September 7, 1984

HOPE CREEK GENERATING STATION
DOCKET NO. 50-354
DRAFT SAFETY EVALUATION REPORT
OPEN ITEM STATUS

Attachment 1 is a current list which provides a status of the open items identified in Section 1.7 of the Draft Safety Evaluation Report (SER). Items identified as "complete" are those for which PSE&G has provided responses and no confirmation of status has been received from the staff. We will consider these items closed unless notified otherwise. In order to permit timely resolution of items identified as "complete" which may not be resolved to the staff's satisfaction, please provide a specific description of the issue which remains to be resolved.

HOPE CREEK GENERATING STATION FINAL SAFETY ANALYSIS REPORT
SAFE LOAD PATH DRAWING (EL. 102) TABLE 9.1-10, ITEMS 7, 8, 39, 40, 41
FIGURE 9.1-35

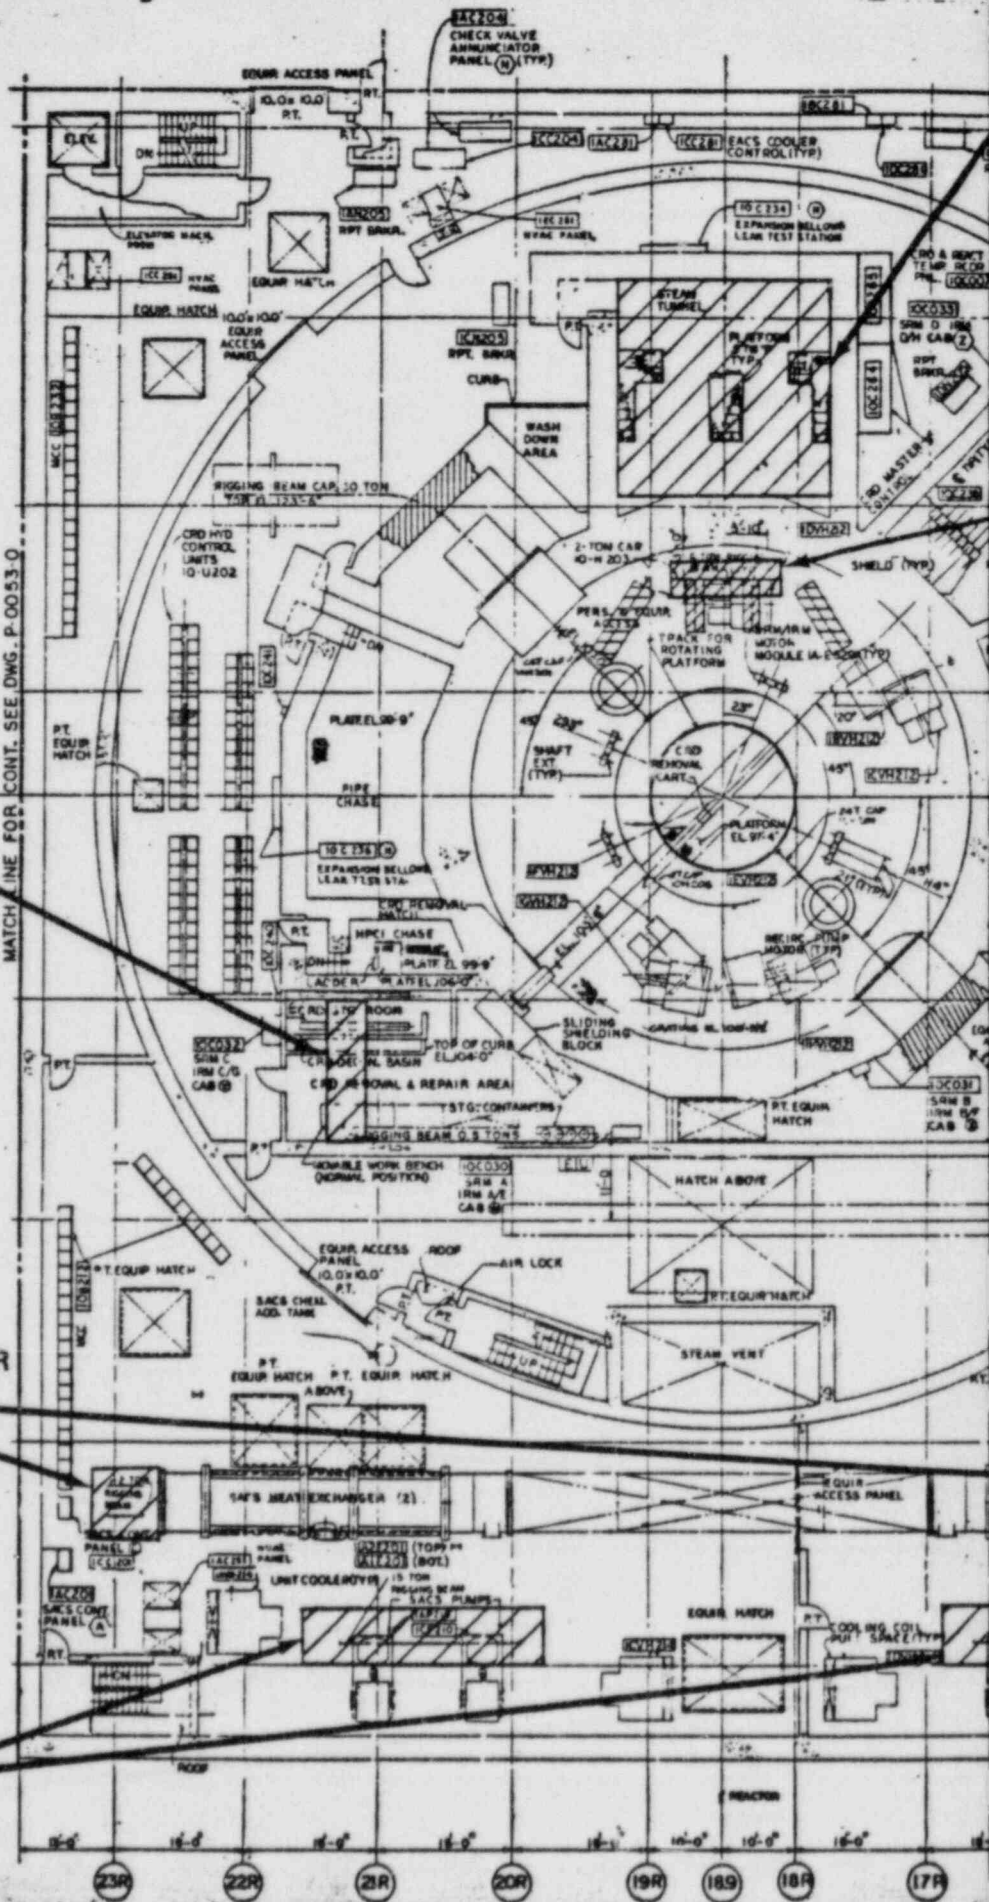
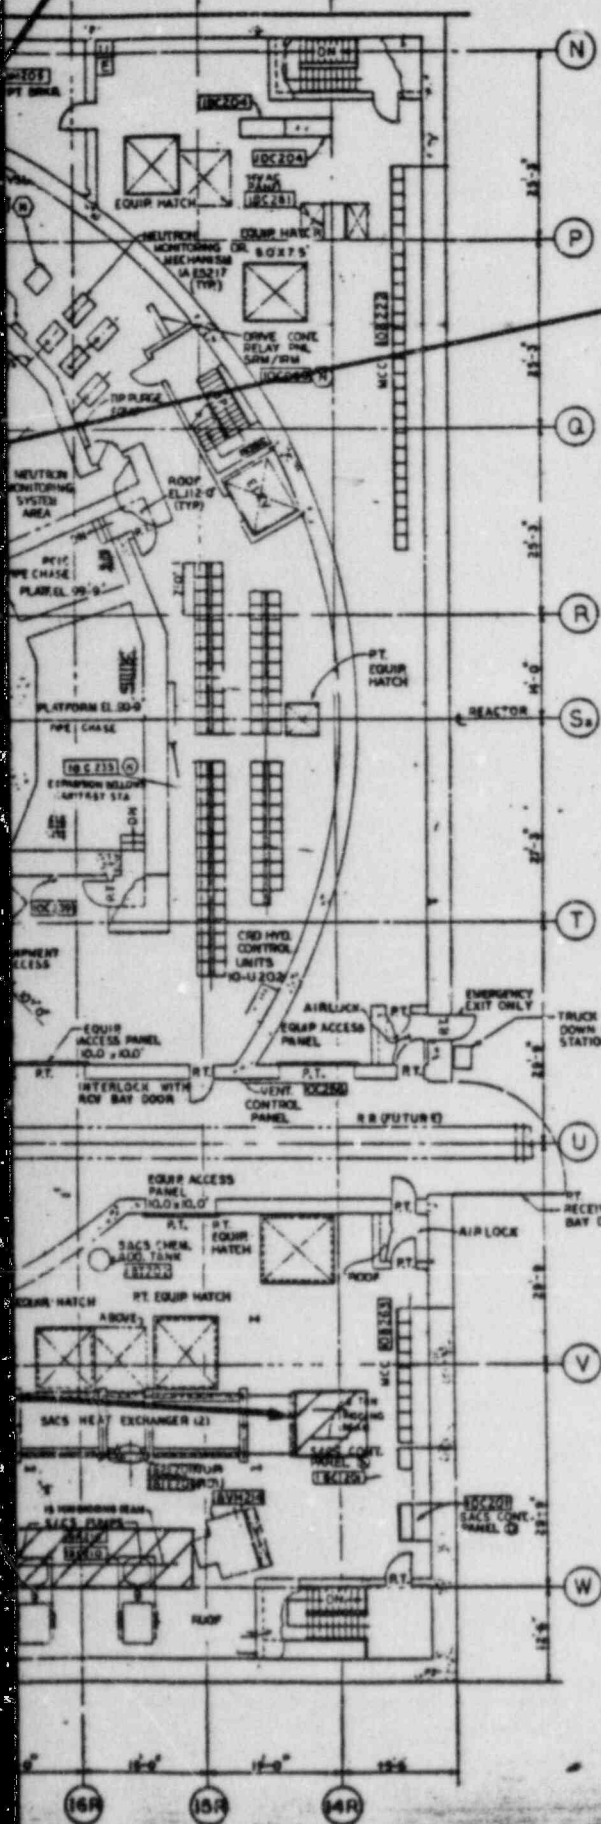
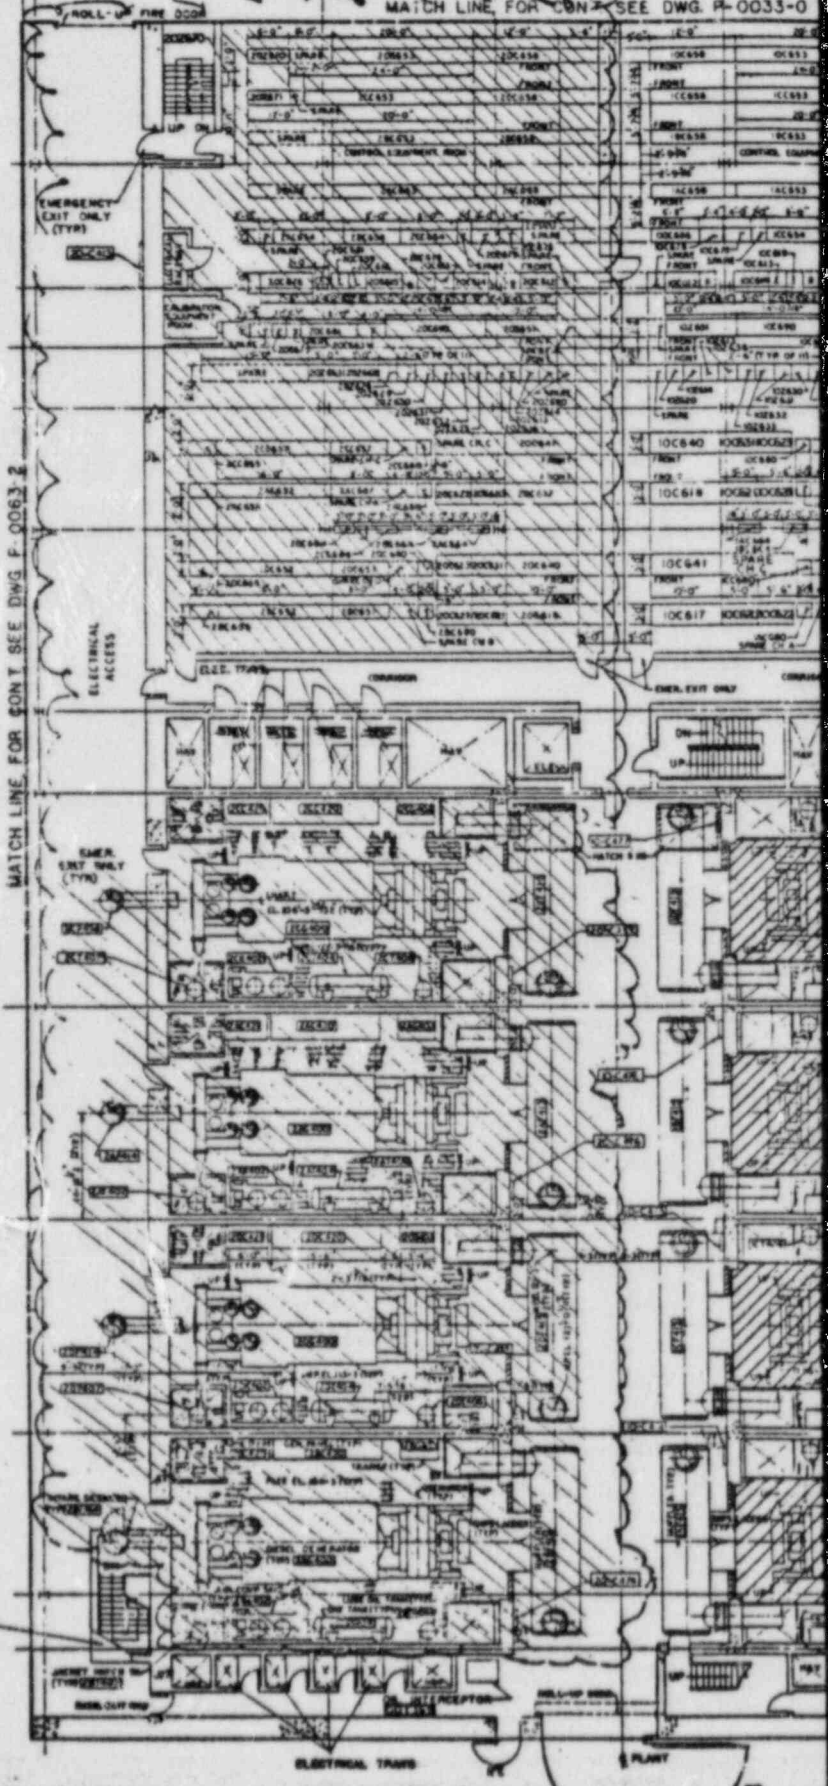
The missing information has been added to Section 9.1.5. The load paths for the CRD service hoist, the SACS pumps hoist, and the SACS heat exchanger hoists have been added to Figure 9.1-35.
